Technical Service Bulletin: tsb100300

New Turbocharger Oil Supply Plumbing for Single-Stage Engine

This Service/Parts Announcement introduces new oil supply plumbing for the turbochargers of the single-stage QSK60 engine.

Figure 1, Old arrangement with oil supply tubes from the flywheel housing.

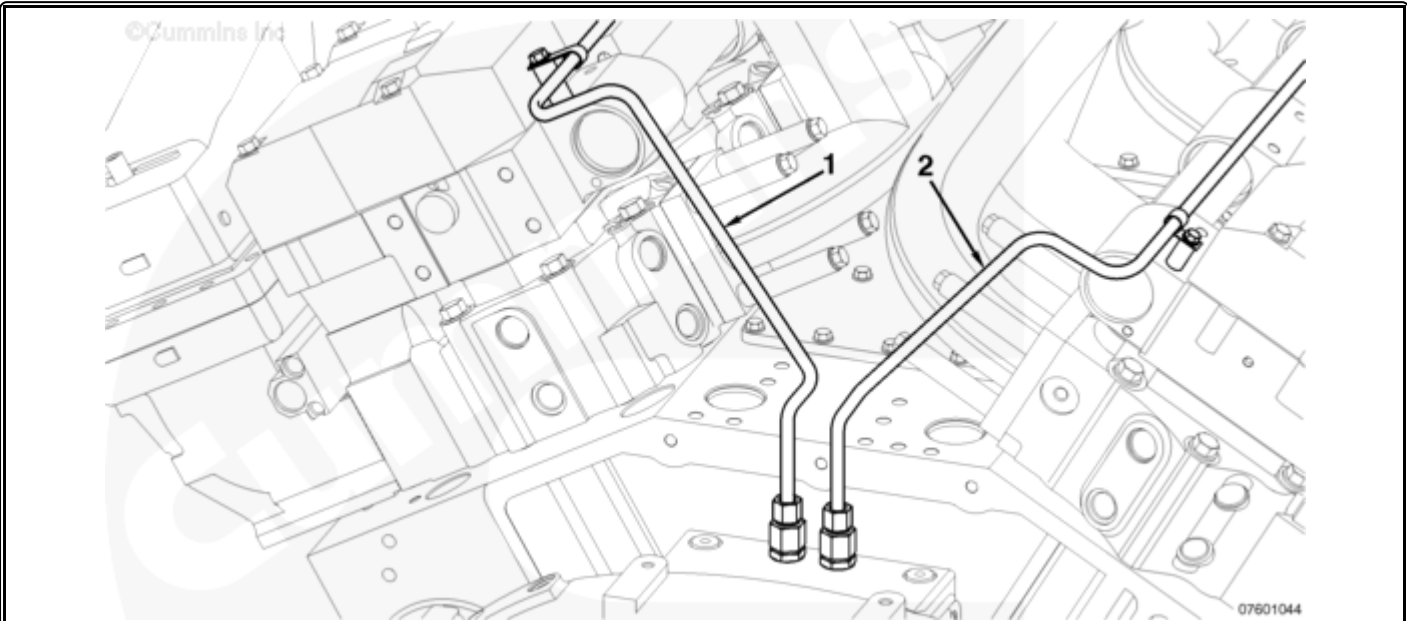
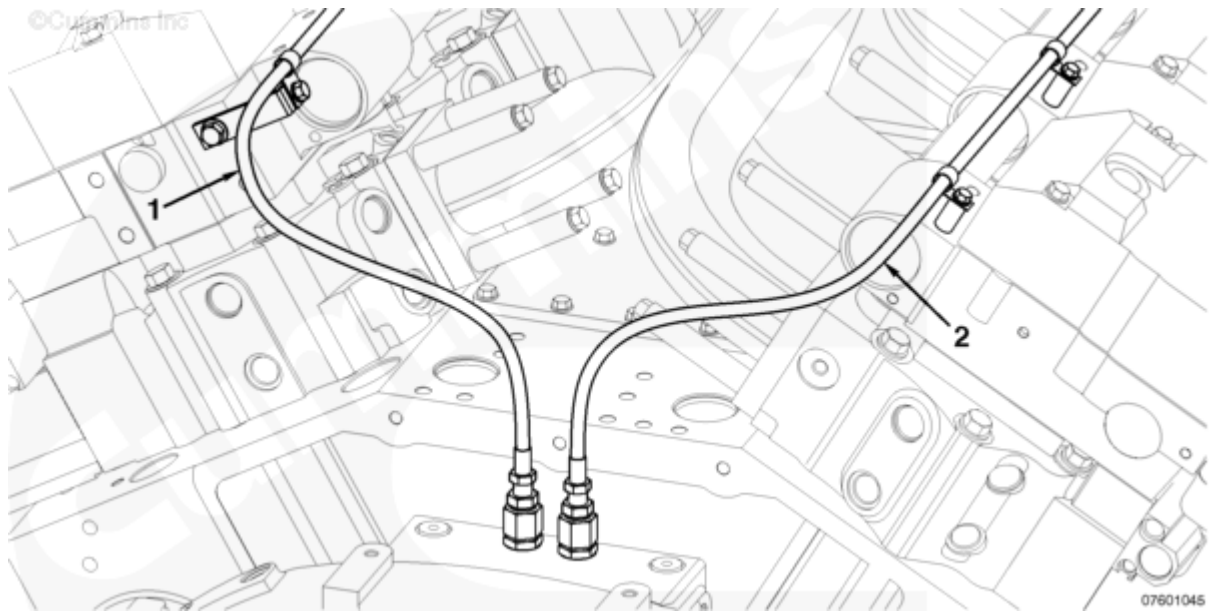
The turbocharger oil supply hoses have been rerouted as illustrated below, constituting a product improvement over the previous hybrid arrangement made of tubes and hoses.

- 1. Old Part Number 3171844 (left bank)
- 2. Old Part Number 3171845 (right bank)

1. New Part Number 3635130 (left bank)
2. New Part Number 3635131 (right bank)

Figure 3, Left Bank, Clips at Number 5 and Number 6 are extended, clips at Number 7 and Number 8 are short.

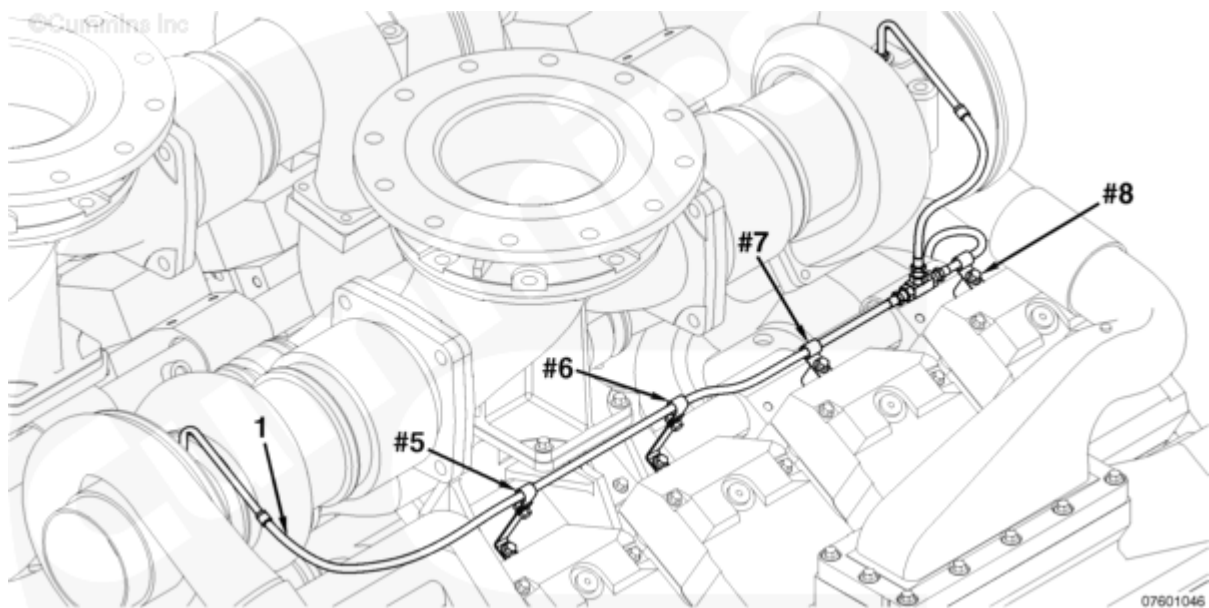
1. New Part Number 3635129 (left bank)

Figure 4, Right Bank, Clips at Number 2 to Number 6 are extended, Clips at Number 7 and Number 8 are short.

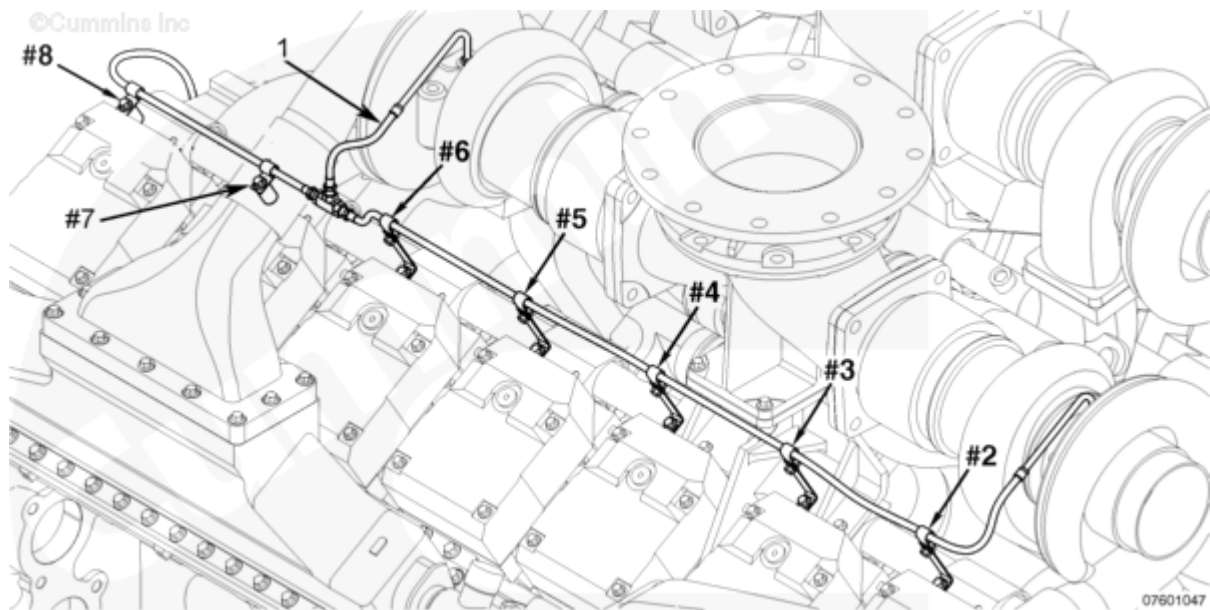
1. New Part Number 3635128 (left bank).
